AMENDMENT NO. 1 NOVEMBER 1993
TO
IS 8167 : 1989 METHOD FOR DETERMINATION OF
REDUCIBILITY INDEX OF IRON OXIDES, LUMP ORE,
SINTER AND PELLETS

(First Revision)

FIG. 3 TYPICAL EXAMPLE OF REDUCTION TUBE

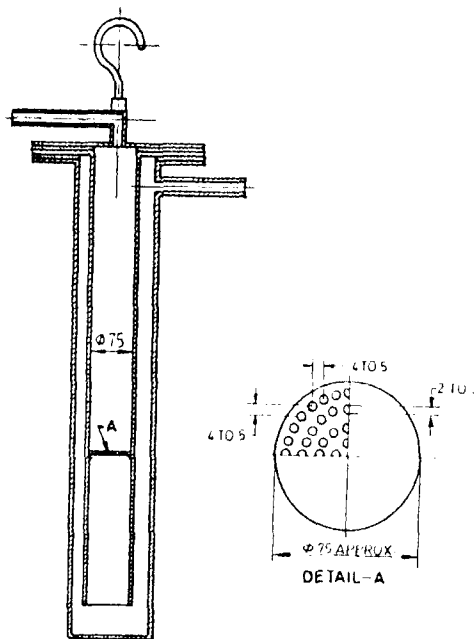
(Page 2, clause 9.3) — Replace the existing matter with the following:

'The reduction tube shall be made of heat-resistant non-scaling metal to withstand temperatures of higher than 950°C. The perforated plate is mounted in the reduction tube for supporting the test portion. The height of the support should be so adjusted that the tube is in the constant temperature zone of the furnace. A typical illustration of reduction tube is shown in Fig. 3 given on next page.'
